DRAFT
EN 12999:2011+A1:2012
prA2

Cranes - Loader cranes

This draft amendment is submitted to CEN members for enquiry. It has been drawn up by the Technical Committee CEN/TC 147.

This document (EN 12999:2011+A1:2012/prA2:2014) has been prepared by Technical Committee CEN/TC 147 “Cranes - Safety”, the secretariat of which is held by BSI.

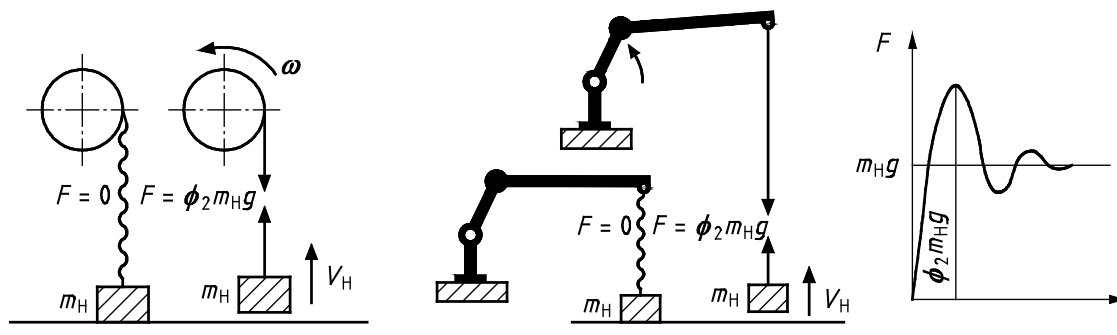
Add to first paragraph after 2nd sentence: "For load combinations A1, B1 and C1, the .."

and after : " or expressed as an equation:

$$\phi_1 = \min (1,1 ; \phi_2)$$

Add new sentence to read: "For load combinations A2 and B2, the value of ϕ_1 shall be 0.95."
